Subject	Waterloo Metro Quarter Over Station Development Addendum to Visual Impact Assessment (Cardno, Final V2, 29 July 2020) [Appendix HH to Environmental Impact Statement] SSD-10437 Southern Precinct		
Author	Nadine Page, Senior Planner	Approved	Sophie Perry, Team Leader, Planning
Project Reference	8021708102	Date	12 February 2021

Modified Proposal

Figure 1 (Left): Submitted Plan (excerpt): Level 24 (Roof) Plan: DWG125 Rev H

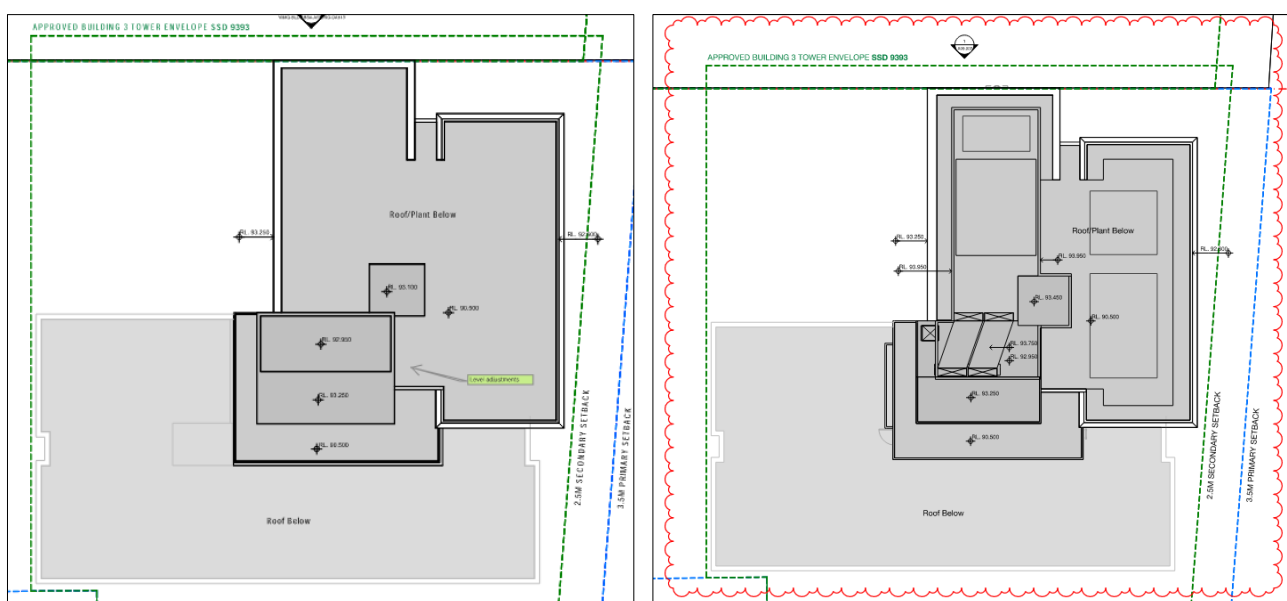
The roof level on the originally submitted design are at RL 90.5 with roof structures located generally at the western portion of the roof at heights at RL 93.1 (comms enclosure); RL 92.50 (stairwell) and RL 93.25 (lift overrun), the latter being the highest point of the building.

The comms enclosure structure increases from RL 93.1 to RL 93.450 (increase of 350mm to this portion of the building); and provision of a screen enclosure at RL 93.950 on the rooftop (northern half). This will become the highest point of the building, being 700mm higher than the originally submitted design.

The screen structure that will form the highest point of the building will be constructed in dark bronze vertical aluminium louvres to compliment the dark and medium bronze materials and finishes of the building façade.
